ADMINISTRATIVE AMENDMENT

PROJECT NUMBER: PR-2021-006307

Application Number: SI-2022-00327

MARKANA MODESTO PHASE II
5051 JOURNAL CENTER BLVD. STE. 500
ALBUQUERQUE, NM 87109
LEGACY DEVELOPMENT AND MANAGEMENT, LLC

SHEET CONTENTS
SITE PLAN
A2.01
21219

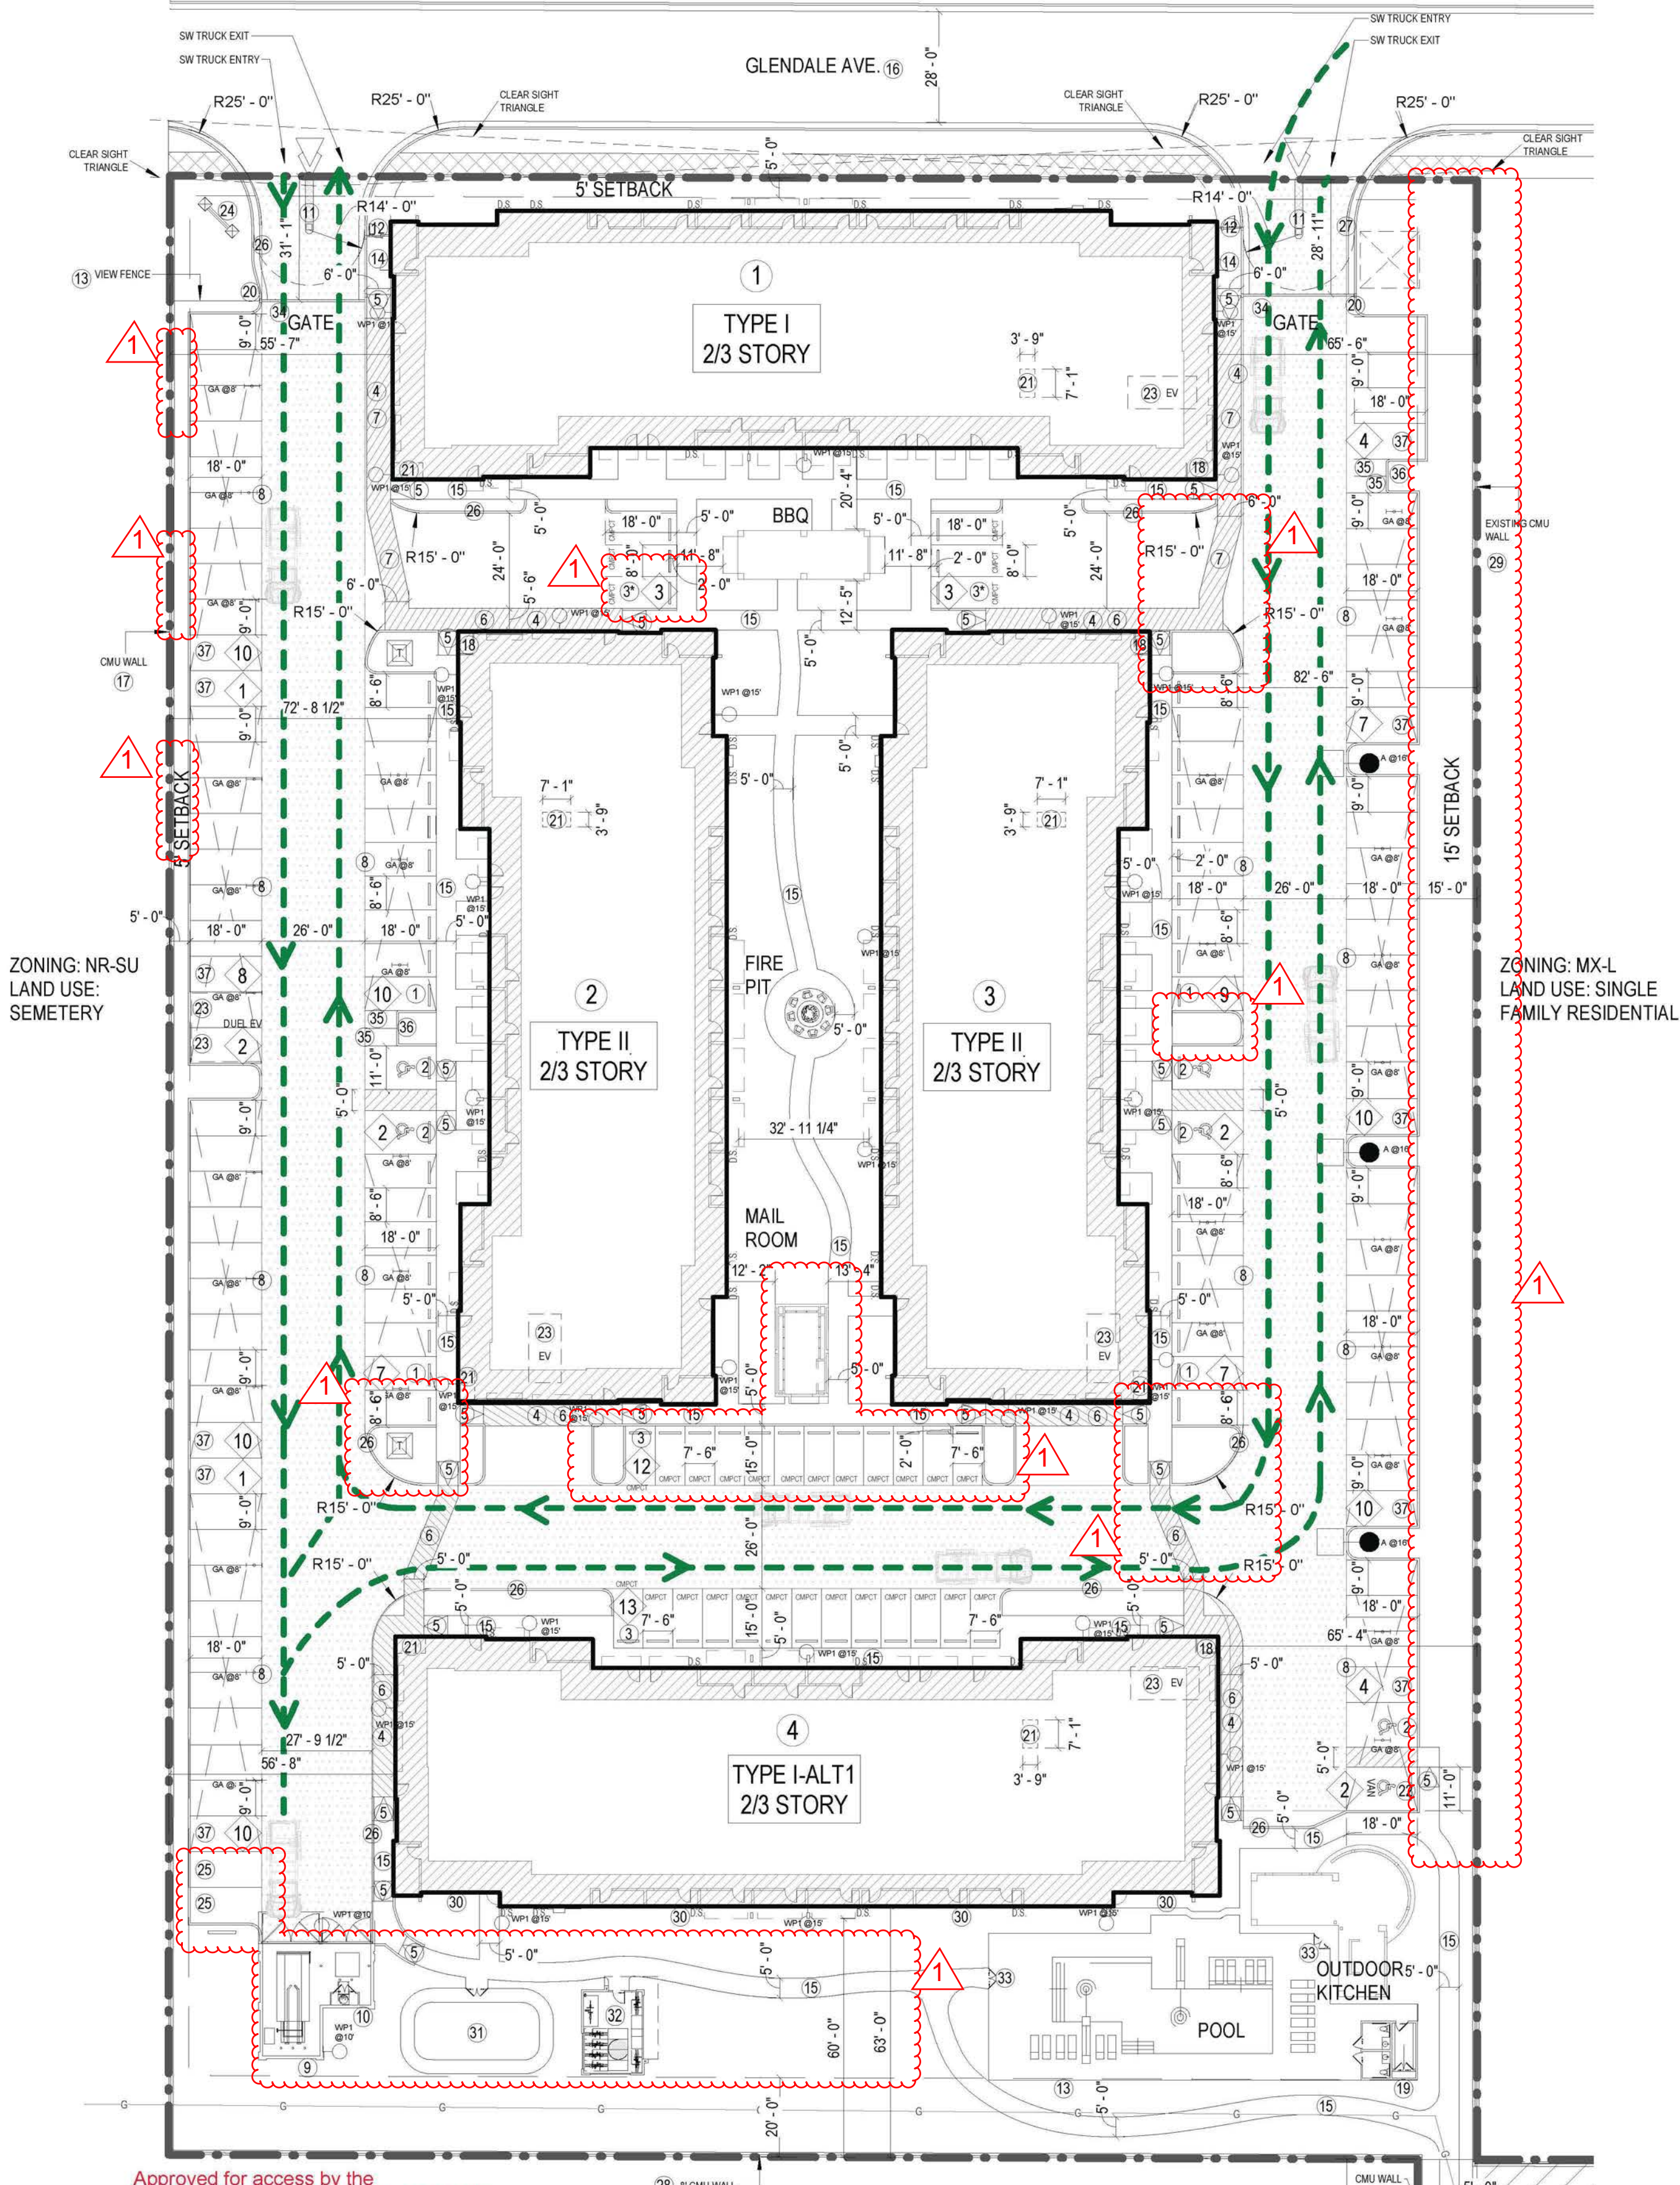
- 11/29/2023 MINOR AMENDMENT:
- CREATED SPACES IN THE WEST CMU WALL AND FILLED THOSE SPACES WITH METAL FENCING (NO FOOTING) IN ORDER TO MAINTAIN THE HEALTH OF THE EXISTING TREES.
 - ADDED CURVED RETAINING WALLS FOR THE TREES DUE TO THE EXISTING SLOPE.
 - REPLACED TURF AREA WITH PICKLEBALL COURT AND MADE ADJUSTMENTS TO LAYOUT.
 - ADJUSTED PARKING AND END ISLANDS TO RESPOND TO PNM'S REQUEST FOR CLEARANCE AROUND THE SITE TRANSFORMERS AND ADJUSTED PARKING LAYOUT.

SHEET CONTENTS
SITE PLAN
SHEET NO.
A2.01a
21219

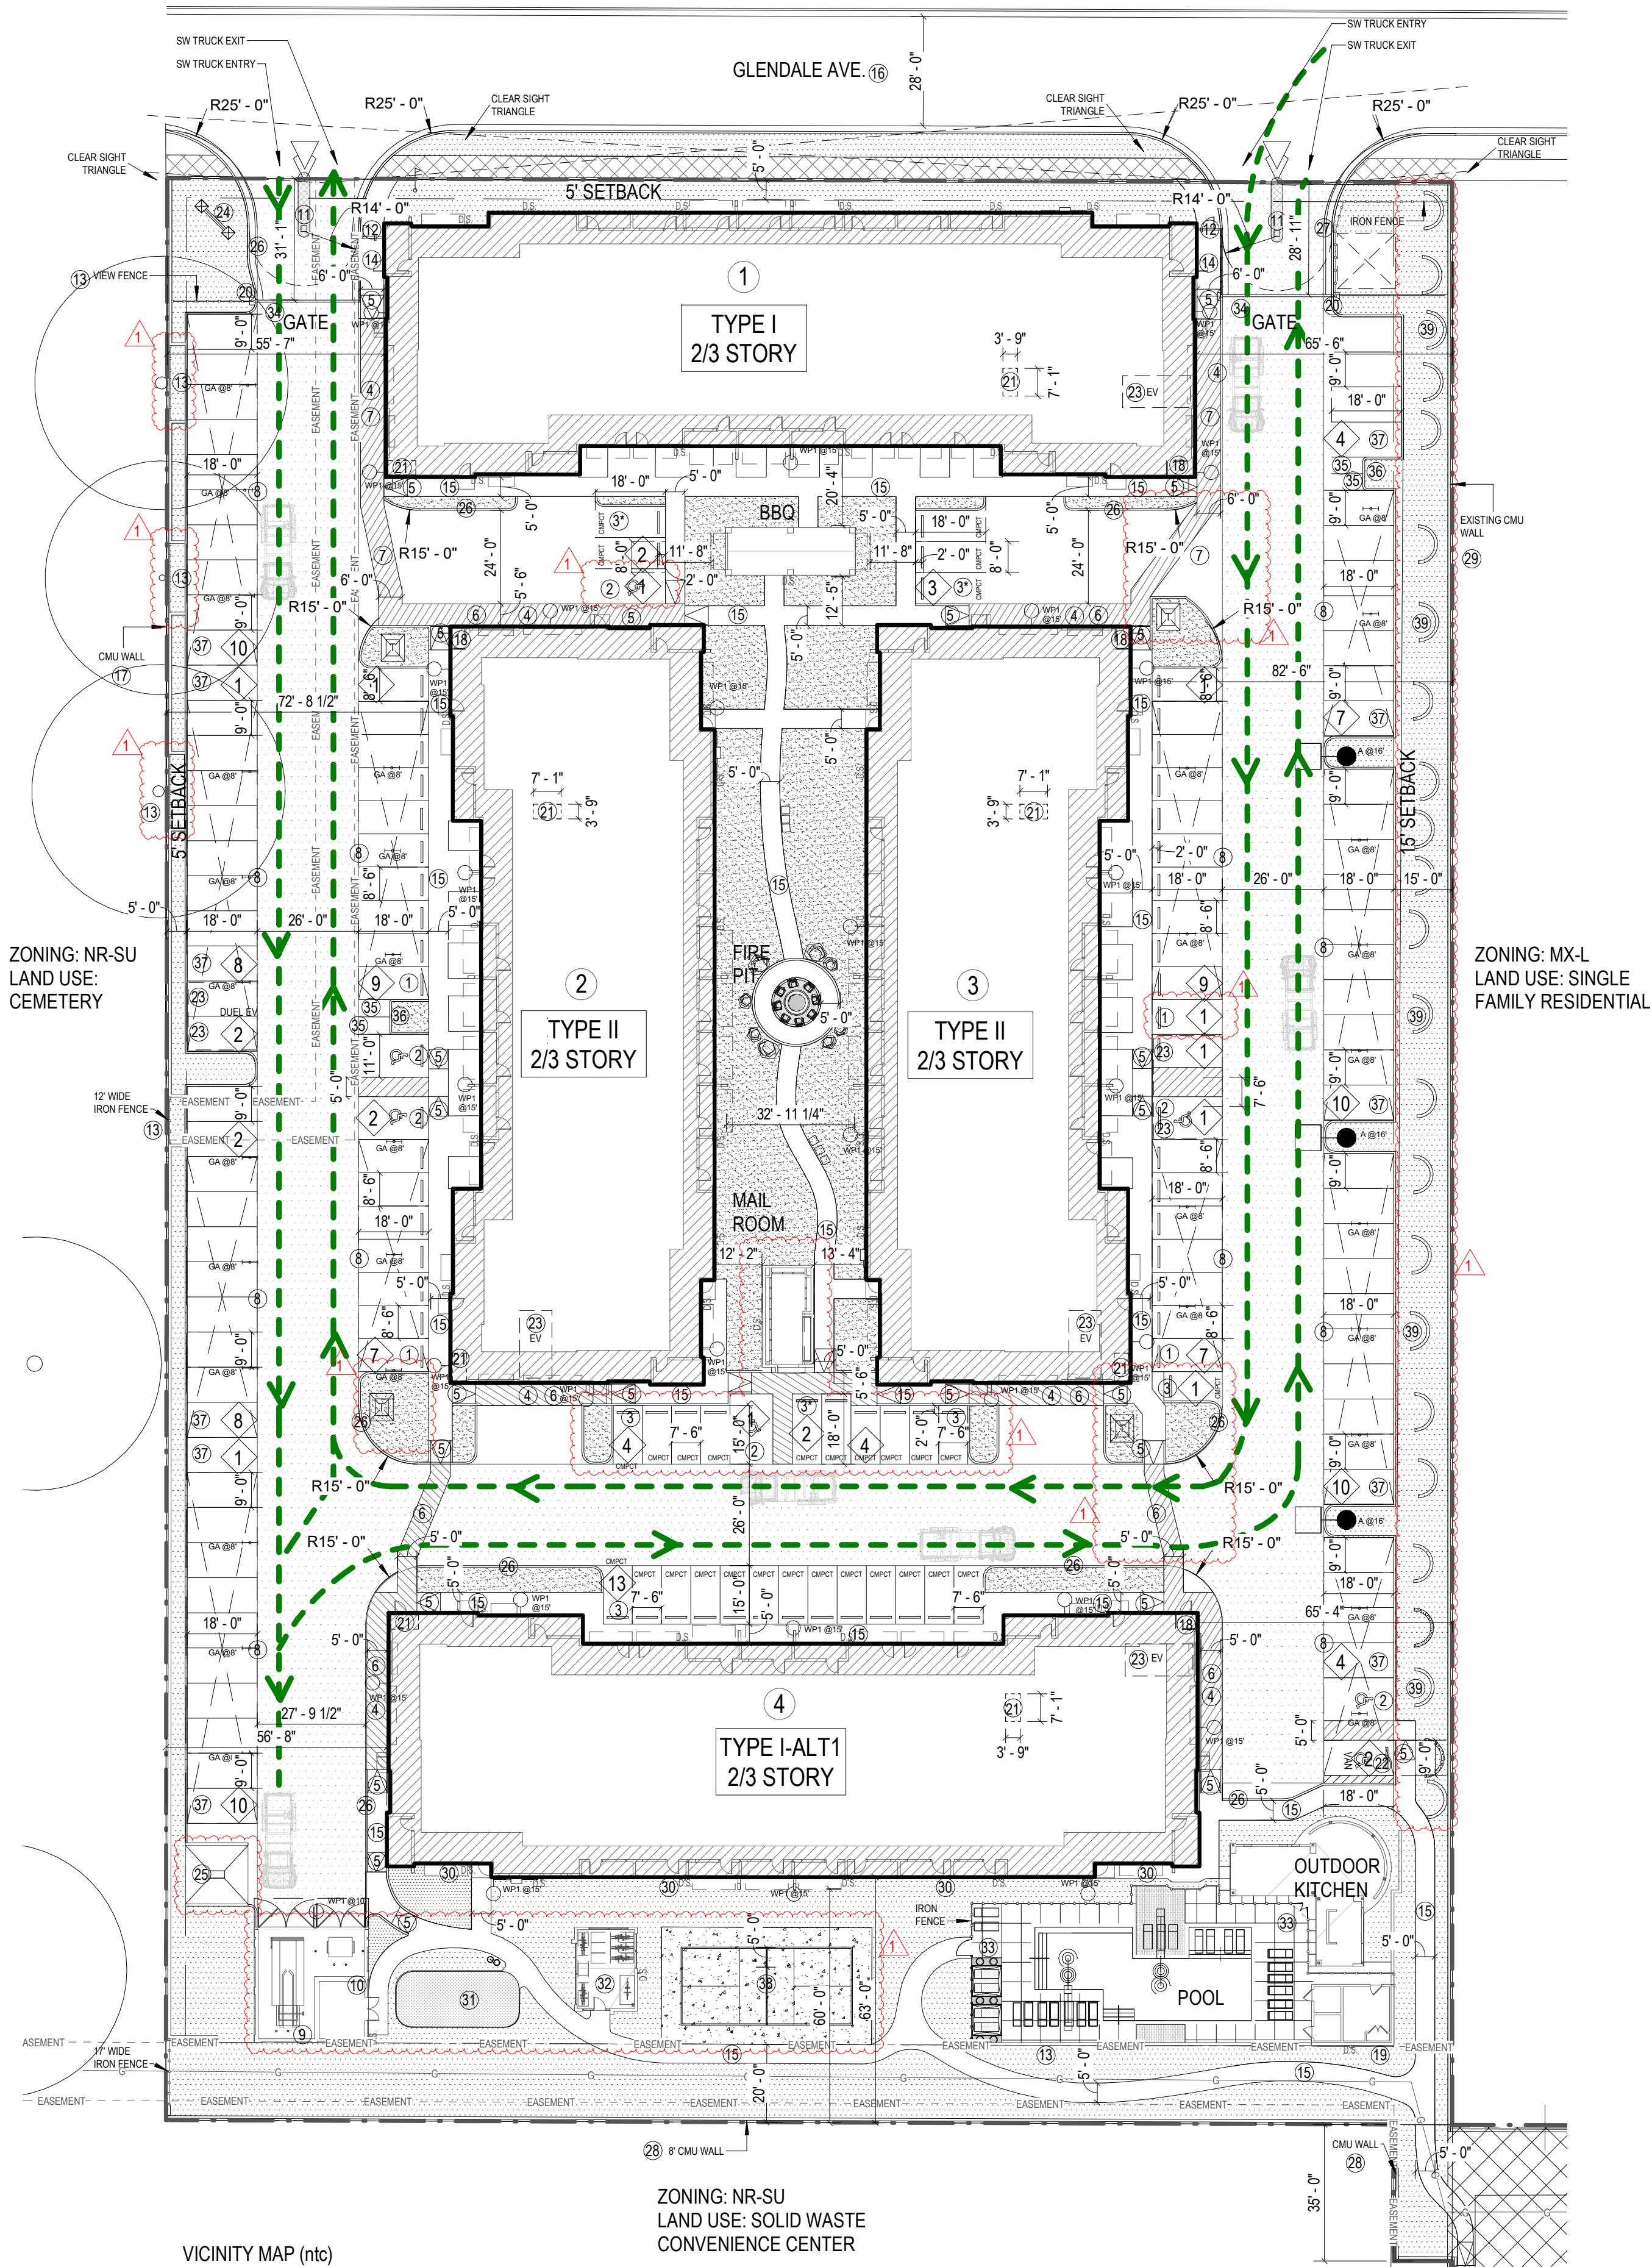
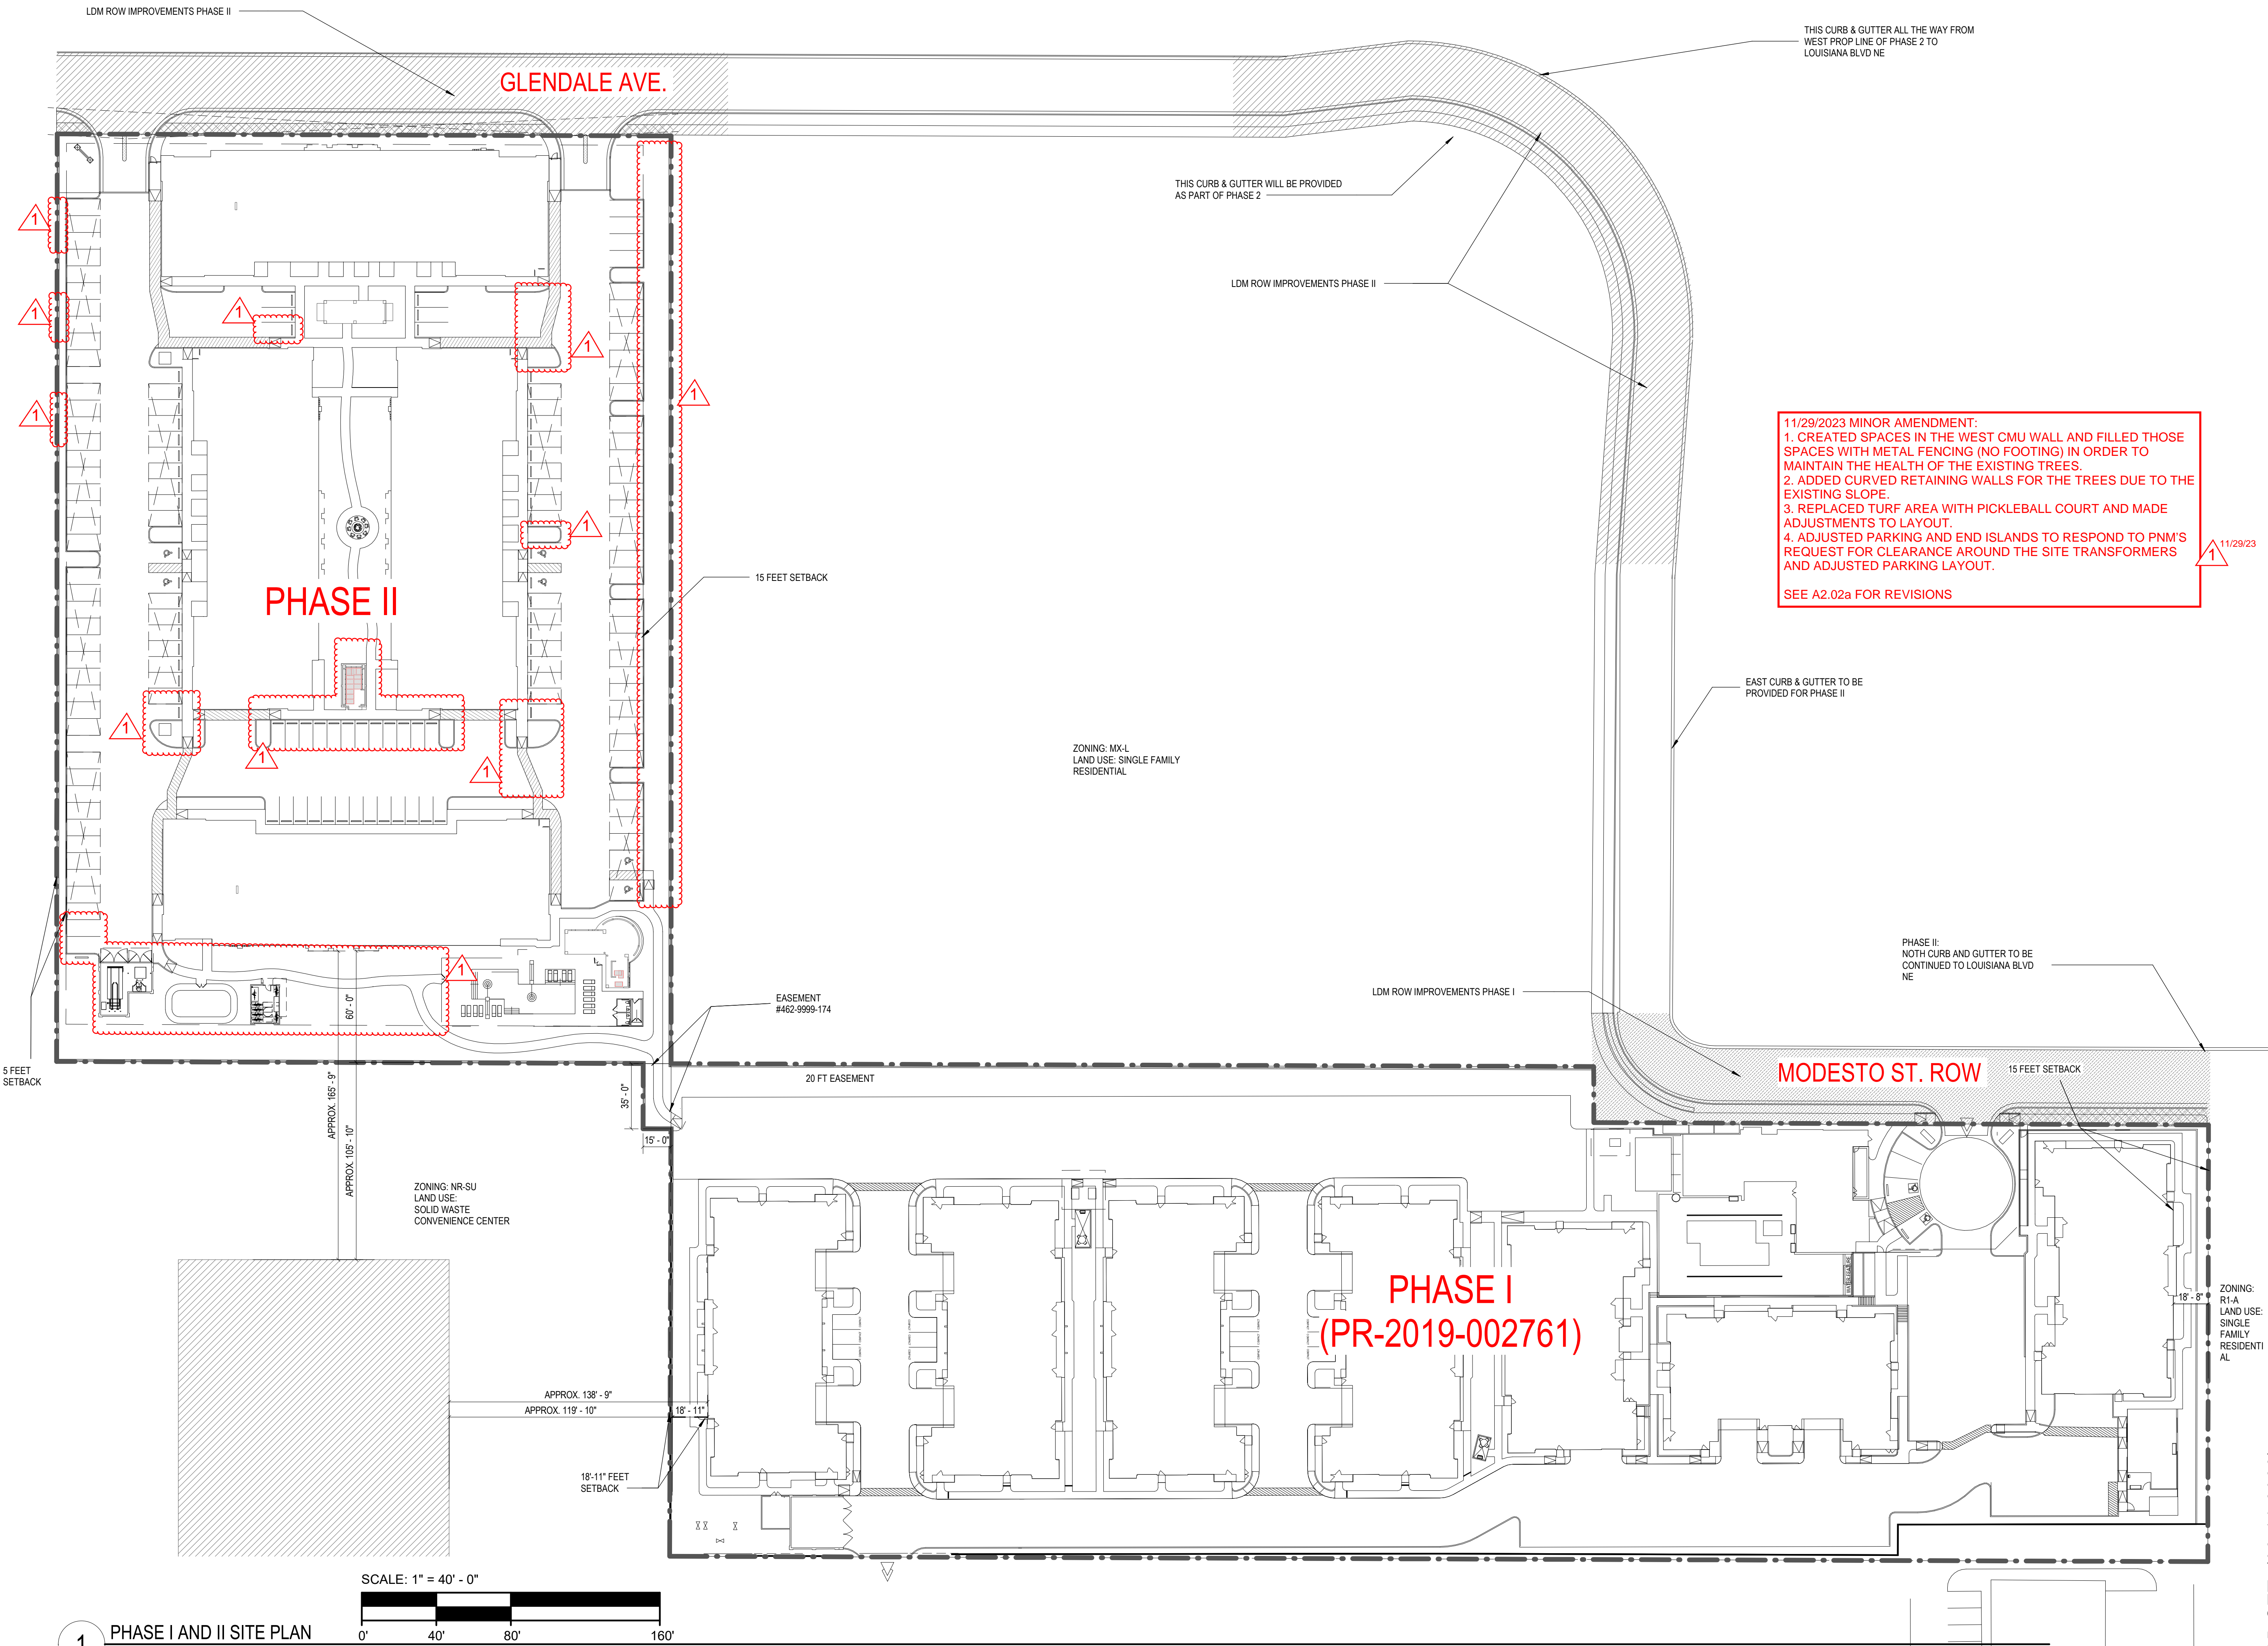
11/29/2023 MINOR AMENDMENT:

- CREATED SPACES IN THE WEST CMU WALL AND FILLED THOSE SPACES WITH METAL FENCING (NO FOOTING) IN ORDER TO MAINTAIN THE HEALTH OF THE EXISTING TREES.
- ADDED CURVED RETAINING WALLS FOR THE TREES DUE TO THE EXISTING SLOPE.
- REPLACED TURF AREA WITH PICKLEBALL COURT AND MADE ADJUSTMENTS TO LAYOUT.
- ADJUSTED PARKING AND END ISLANDS TO RESPOND TO PNM'S REQUEST FOR CLEARANCE AROUND THE SITE TRANSFORMERS AND ADJUSTED PARKING LAYOUT.
